Comments on the Millsite Tailings Storage Facility Reclamation Project:

The following comments are submitted on behalf of the Federation for Sustainable Environment (FSE). The FSE is a federation of community based civil society organisations committed to the realisation of the constitutional right to an environment that is not harmful to health or well-being, and to having the environment sustainably managed and protected for future generations. Their mission is specifically focussed on addressing the adverse impacts of mining and industrial activities on the lives and livelihoods of vulnerable and disadvantaged communities who live and work near South Africa's mines and industries.

Localities of the water sampling points, showing the Tier 1 risk classes⁶ for uranium with the blue arrow pointing to the Tweelopiespruit to the north and Wonderfonteinspruit to the south

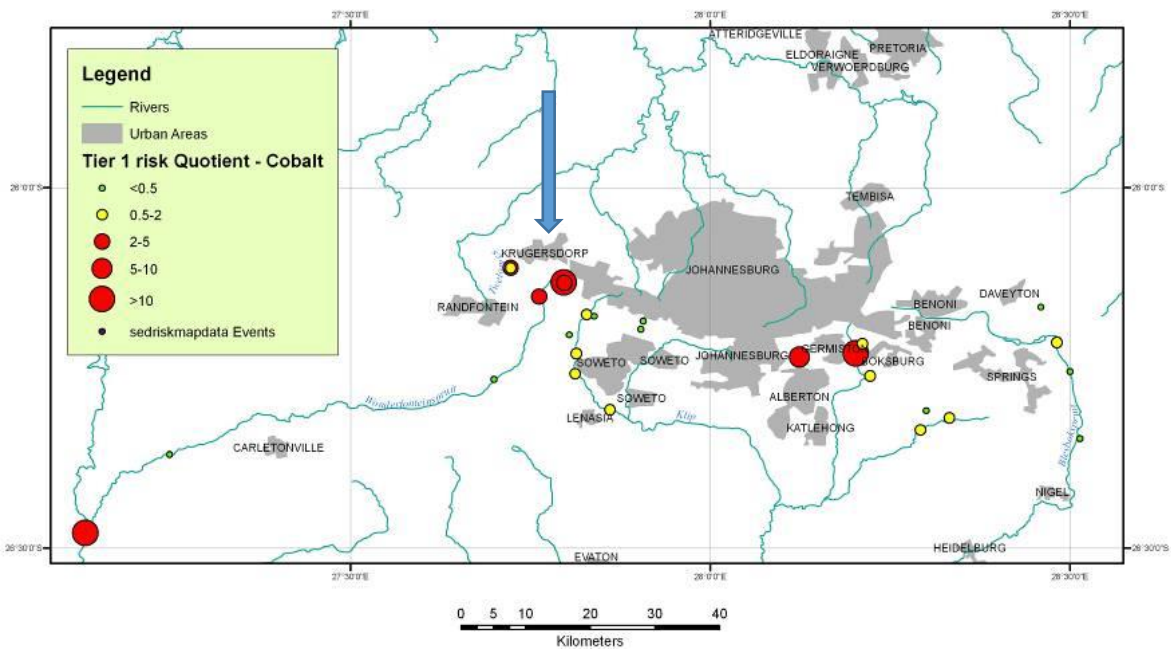
While the wetlands system associated with the Tweelopiespruit and the Wonderfonteinspruit was historically successful in adsorbing and sequestering the metals, the wetlands no longer have the ability to cope with the pollutant loads flowing into them. The wetlands have historically acted as metallic pollutant sinks. There is the identified risk of the remobilisation – under plausible environmental conditions - of metals from the sediments within the wetlands.

In the light of the aforesaid, we recommend that the Surface Water Assessment Report should include in its potential surface water impacts the risk of the remobilisation of metals in the sediment of the wetlands into the water bodies of the Wonderfonteinspruit and
